MOUNT OWEN CONTINUED OPERATIONS PROJECT

Response to Queries Raised by
Agencies Following
Response to Submissions

November 2015

FIGURE 4.3
 Conceptual Surface
 Water Management
 Year 5

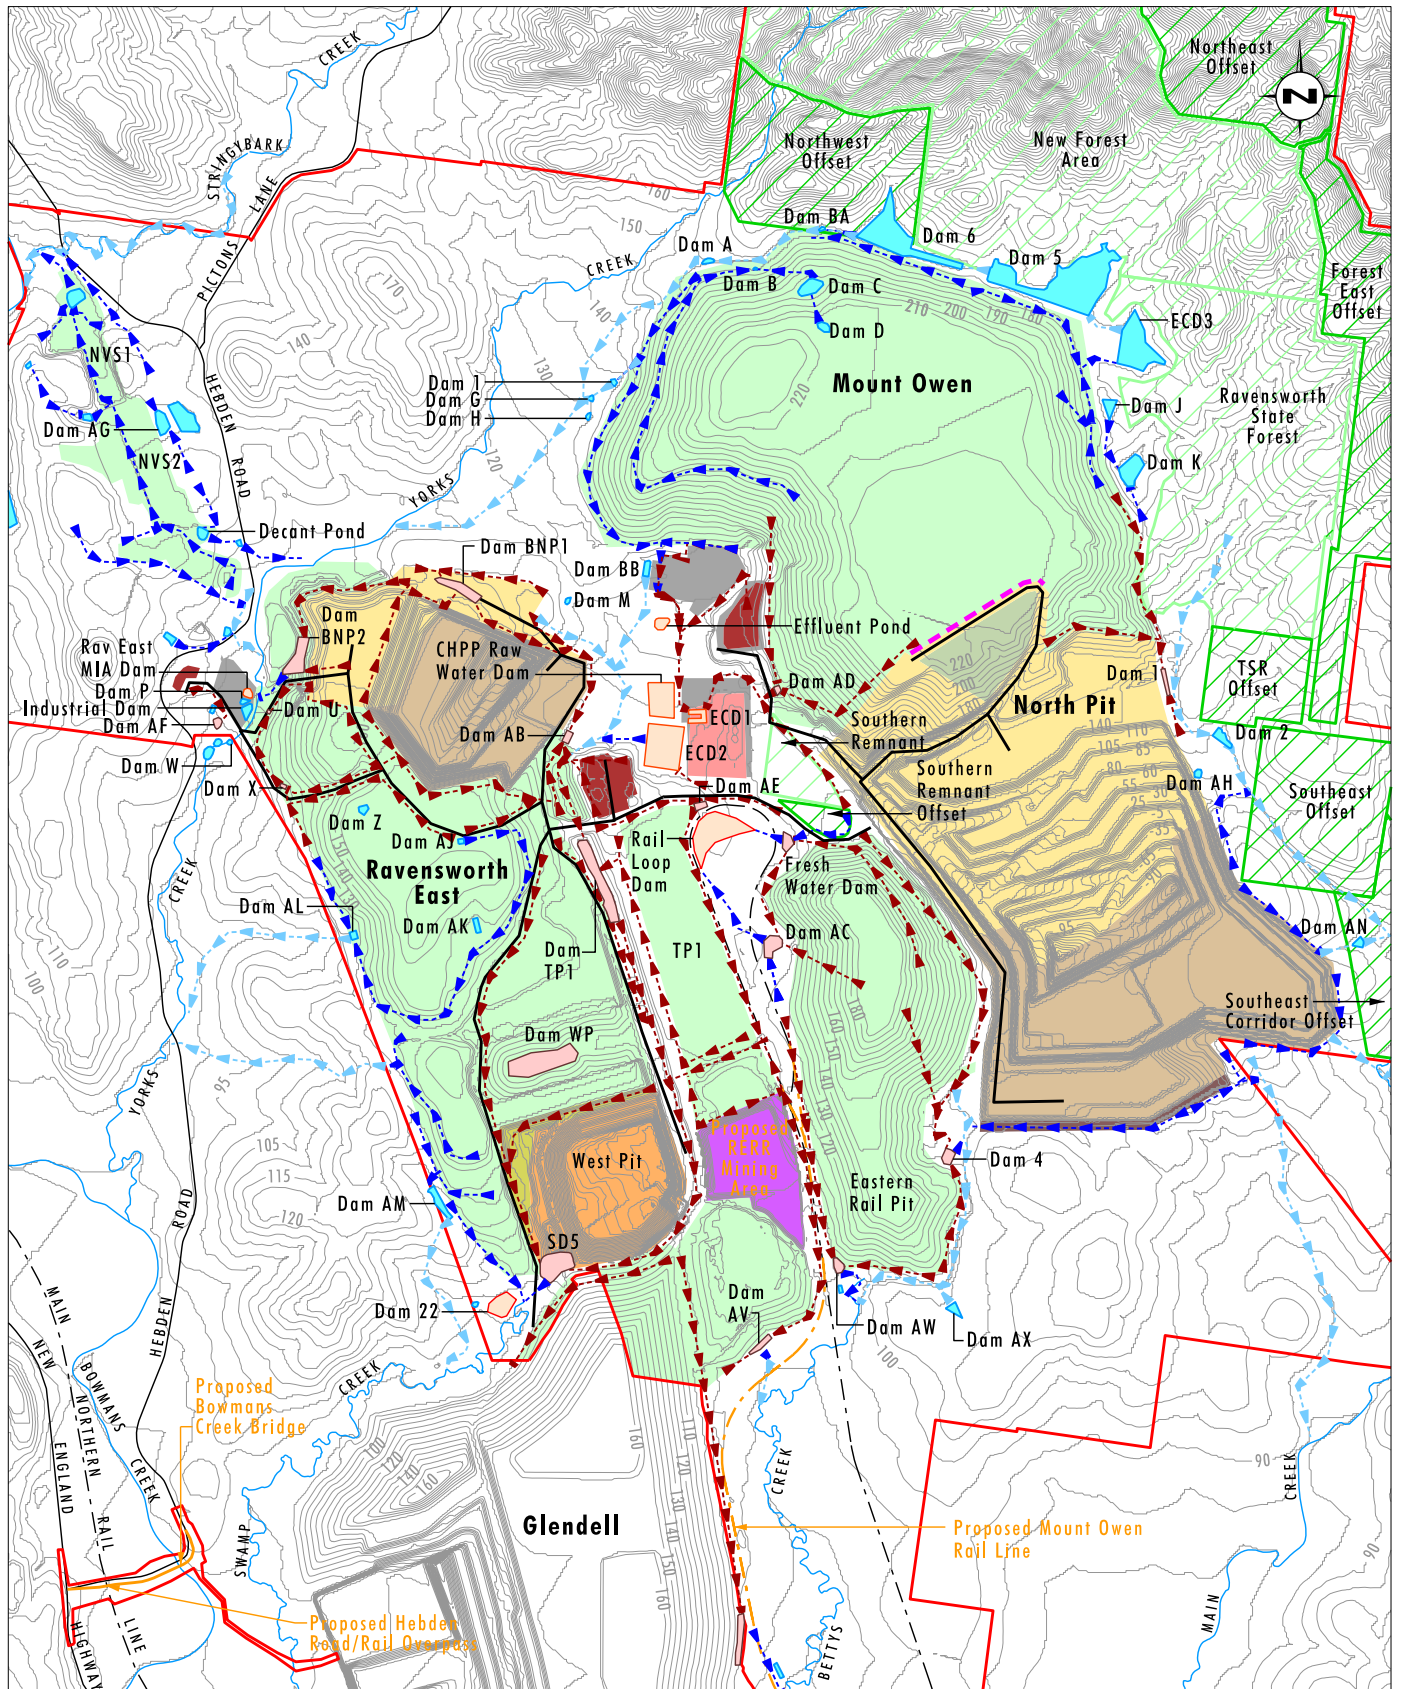
- ***In Years 5 and 10 there are clean water diversions from Ravensworth East into Dam X (as shown in Figures 4.3 and 4.4 of the EIS), which is a dirty water dam. Further explanation of this clean water capture in dirty water dams is required.***

See earlier response.

The clean water drains identified in Figures 4.3 and 4.4 of the SWA have been inadvertently left off Figure 4.2 however it should be noted that Figure 4.2 includes dirty water drains in this location which is an accurate characterisation of the catchment. The characterisation of the catchment as being part of the water management system in Figure 4.7 and 4.8 of the RTS Report A is correct.

FIGURE 4.4

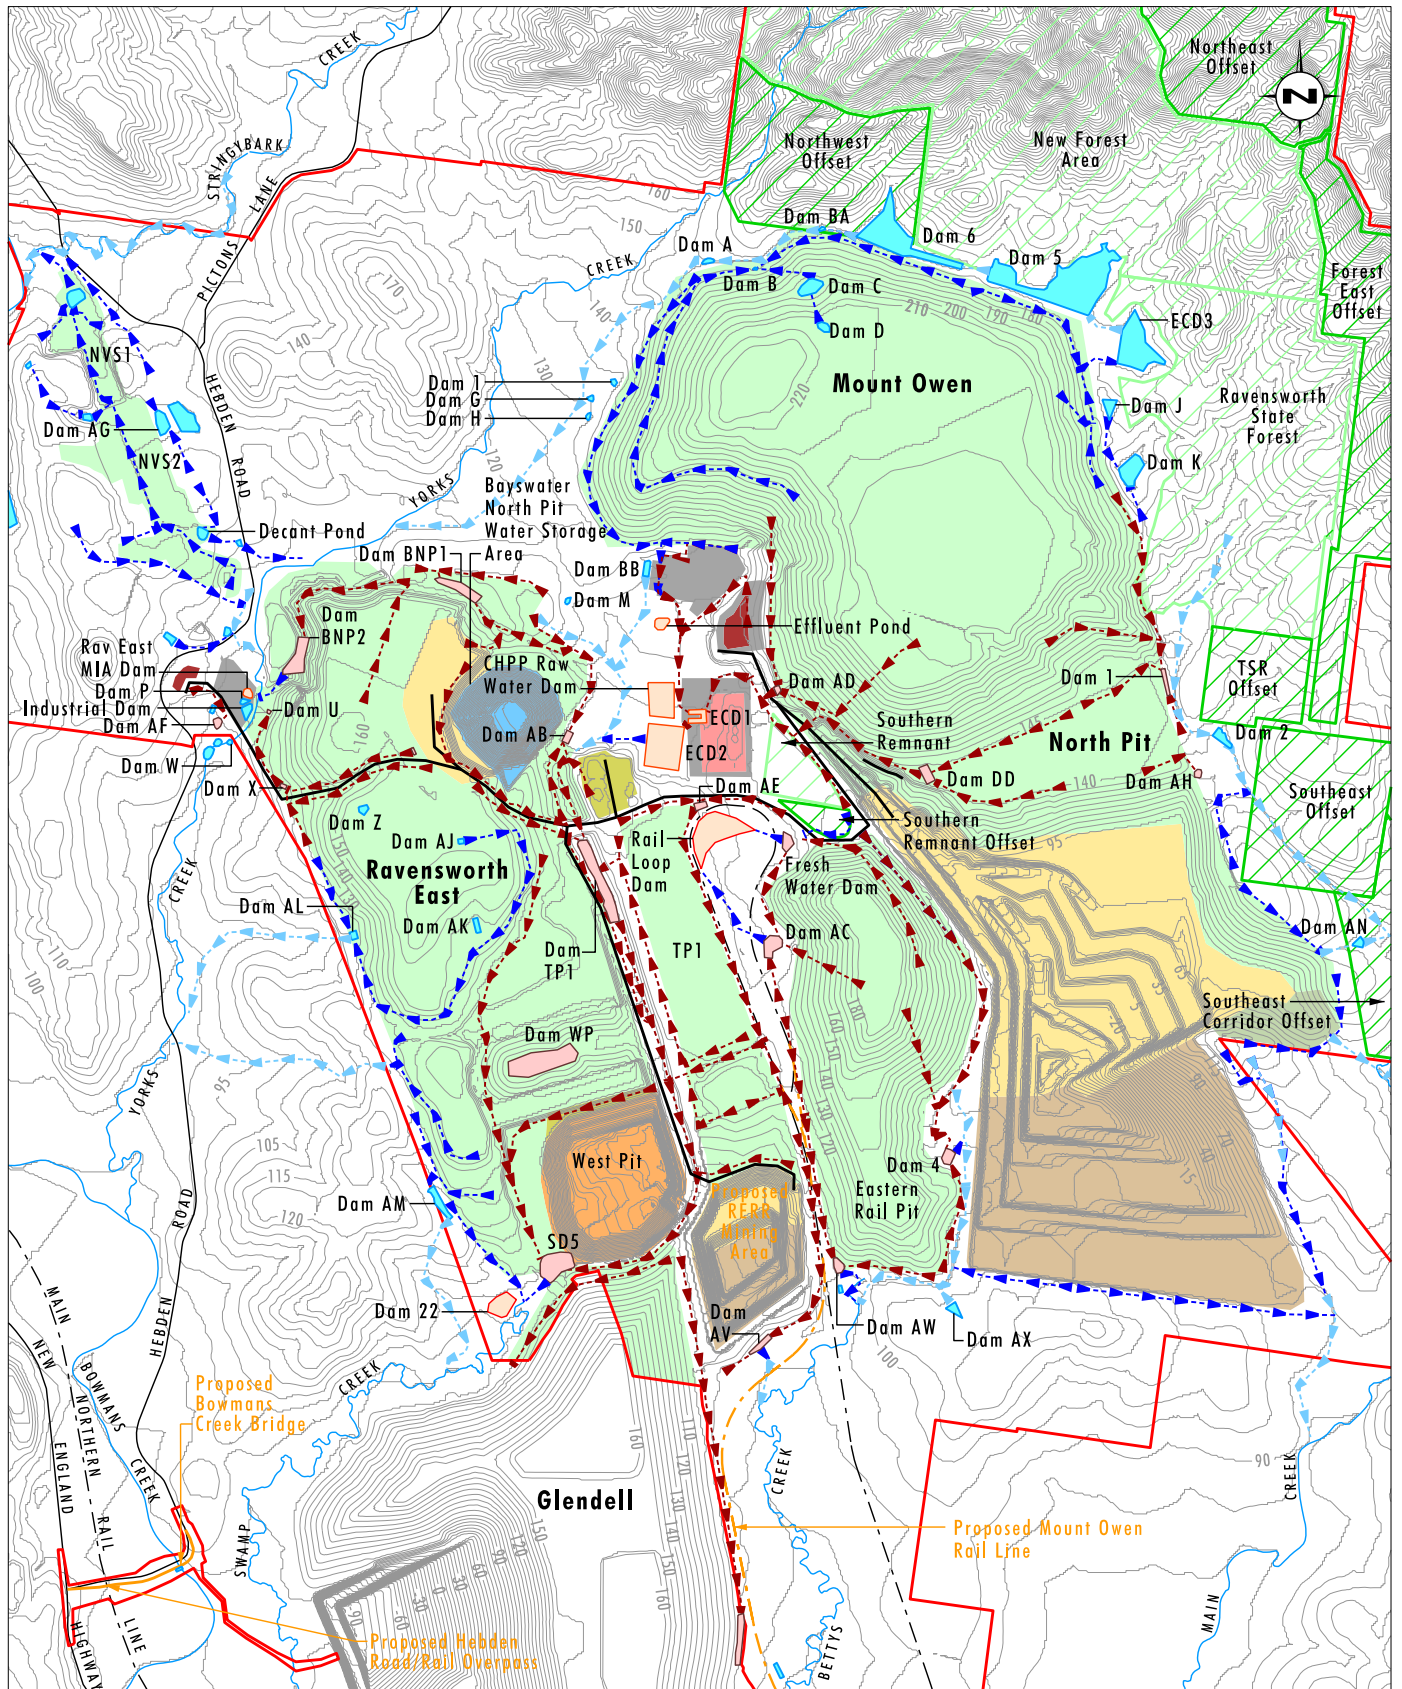
- ***In Year 10 there appears to be clean water captured in Dam AD (subsequently going into ECD1) that is not shown in the area of clean water capture in Figure 4.8.***

- ***In year 10 there are clean water diversions into SOS (as shown in Figure 4.4 of the EIS), which is a dirty water dam. Further explanation of this clean water capture in dirty water dams is required.***

This area, while planted, is still in the rehabilitation establishment phase and runoff from this area is not predicted to be of sufficient quality to discharge to the environment until closure.

This flowpath has been updated to be shown as a dirty water drain in Figures 4.2 and 4.4 in the Surface Water Assessment. The characterisation of the catchment as being part of the water management system in Figure 4.8 of the RTS Report A is correct.

The rehabilitated areas of the catchment of SD5, while planted, is unlikely to be of sufficient standard that the runoff from these areas will be of sufficient quality to discharge to the environment. All flowpaths shown as flowing to SD5 should be shown as dirty water drains.
